Central Falls High School

100% Construction Documents

Central Falls, RI Ai3 Project #2202.02

Addendum #6

DRAWING NAME: DRAINAGE PLAN

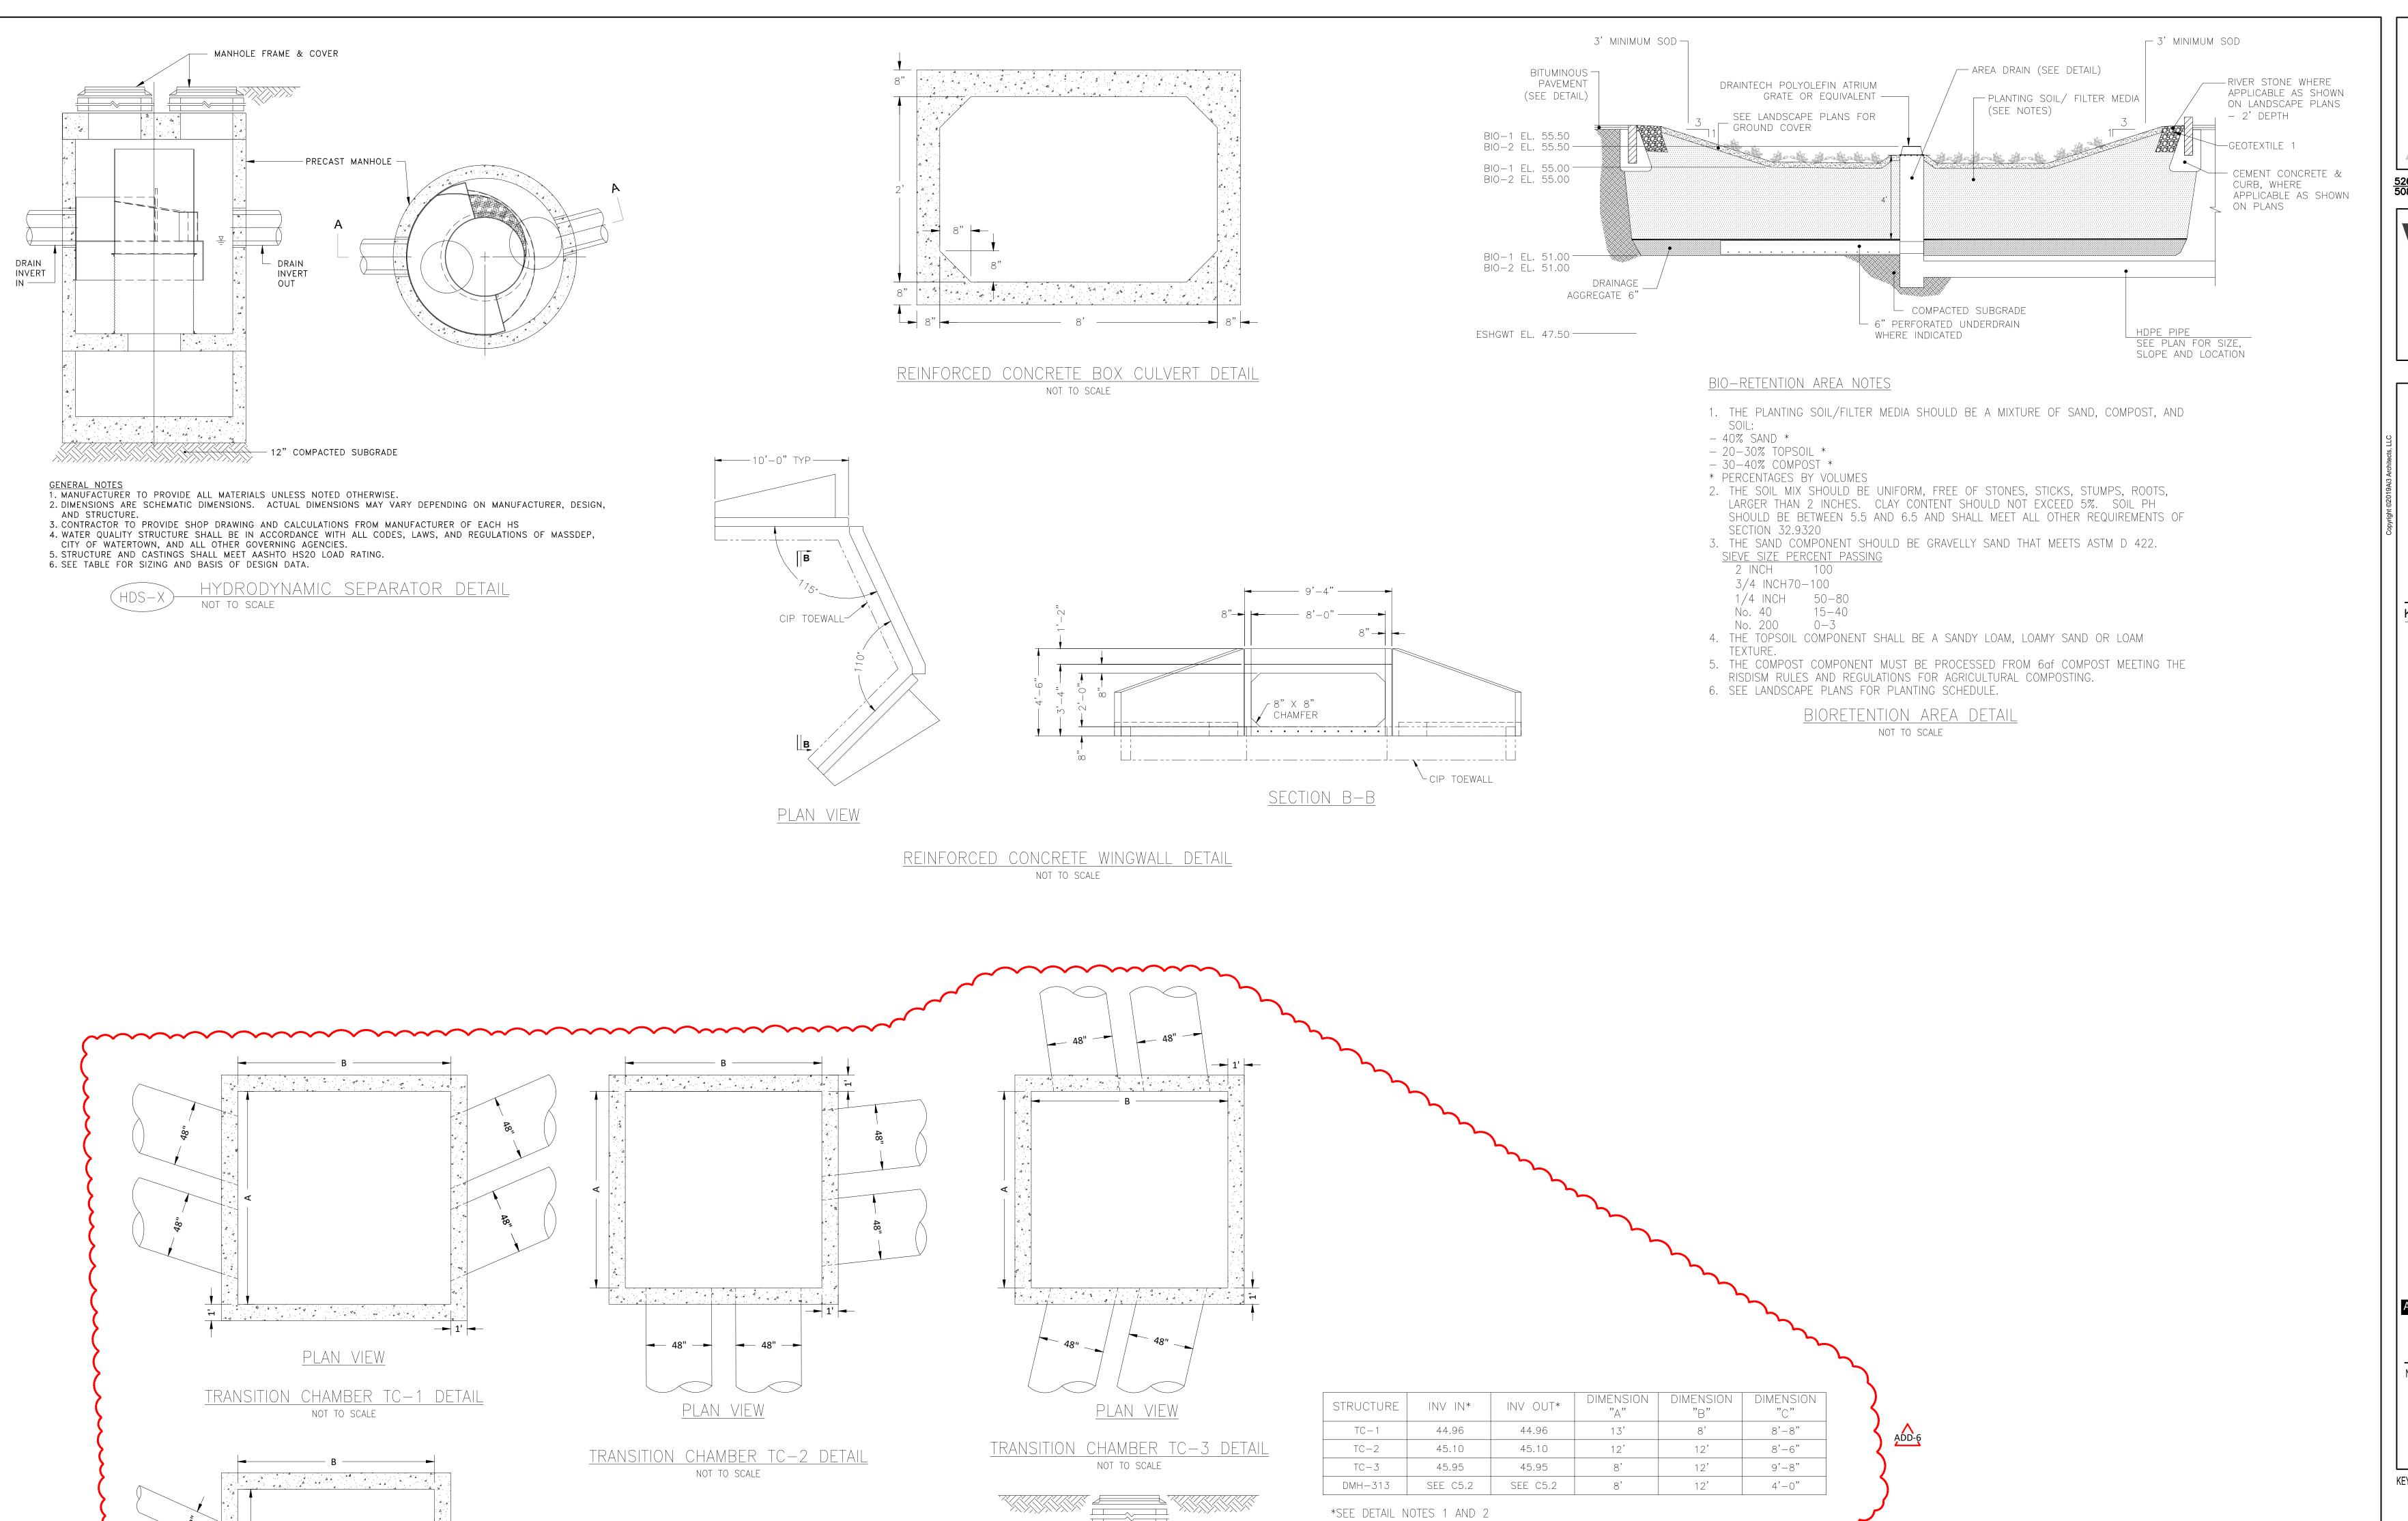
Bidder Question: Please provide more information on the concrete vaults shown on C5.1 for the relocation of the twin 48" RCP pipe, not limited to, vault details, vault inverts, reinforcement requirements, etc.. Also, only TC-1 calls for it to be cast-in-place, is the intent for all 3 vaults to be cast-in-place.

ADD 6-034 **Bidder Question:** Please refer to C5.1, where TC-1 "connects" to the existing concrete culvert, please provide more detail on this

Bidder Question: Please refer to C5.1, Note 9, which calls for the concrete vault detention system to be anchored into a concrete slab. There do not appear to be any concrete vault detention systems on the project. Please confirm this is not required.

Response: Transition chamber details have been added to sheet C6.5, including dimensions, elevations, and reinforcement requirements. All three transition chambers shall be cast-in-place. Transition chamber callouts on Sheet 5.1 have been revised accordingly.

connection and the existing concrete vault. **Response:** The callout on sheet C5.1 has been revised to indicate connection to the existing twin 48" pipes.

Response: The concrete vault detention system is not included in the project. Sheet C5.1 has been revised to remove this note.

BASE PLATE AND PIER DETAILS - 1

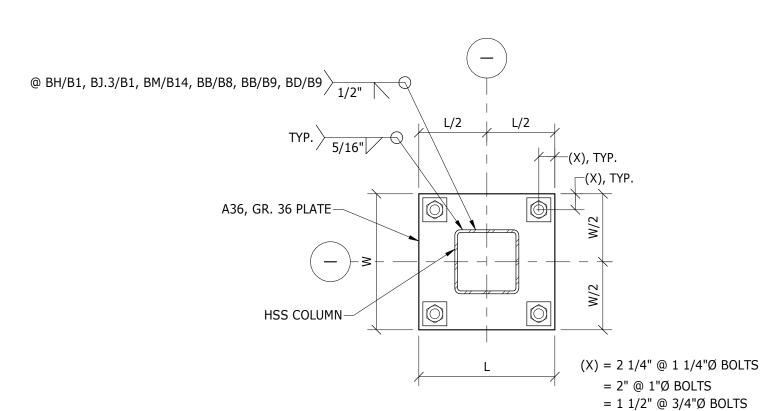
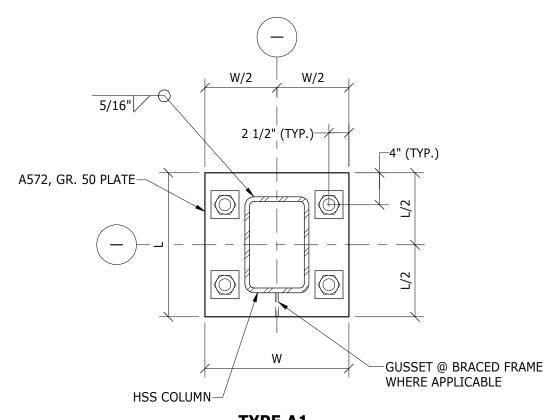
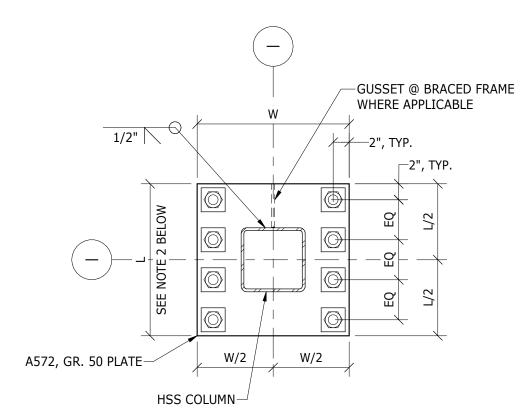
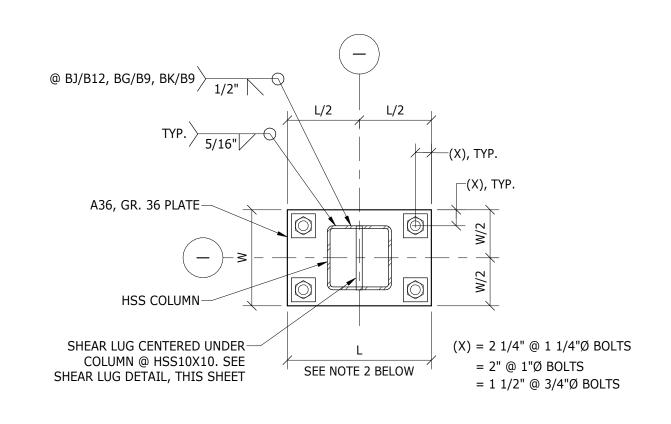
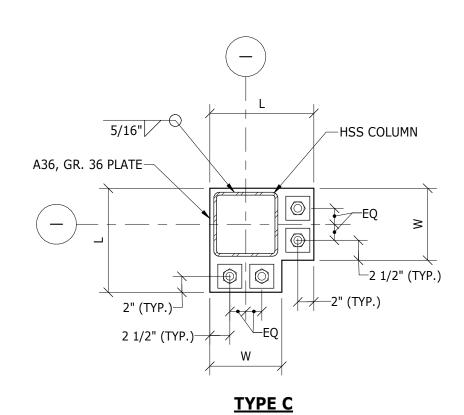
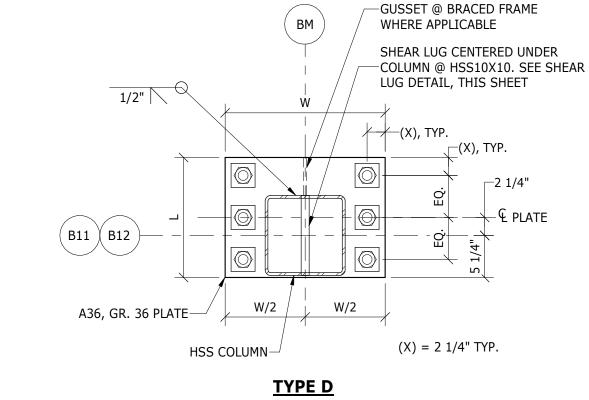
- ADD 6-016 **Bidder Question:** There is a discrepency between detail base plate anchorage and shear lug detail on S2.20. It is written: provide anchor sleeve at base plate with shear lugs and shear struts but nothing is shown on shear lug detail. Please clarify. **Response:** Sleeves are required where shear lugs are required, refer to attached drawings.

- ADD 6-017 **Bidder Question:** Regarding base plate anchorage detail S2.20, please clarify what "Shear Struts" is referring to. **Response**: For shear structs refer to S4.10 "Typical Bracing Connection Details Connection at Column Base w/ Strut Beam" The shear strut reference refers to the back-to-back channels at the base of the brace towers (where applicable). Refer to attached drawings.
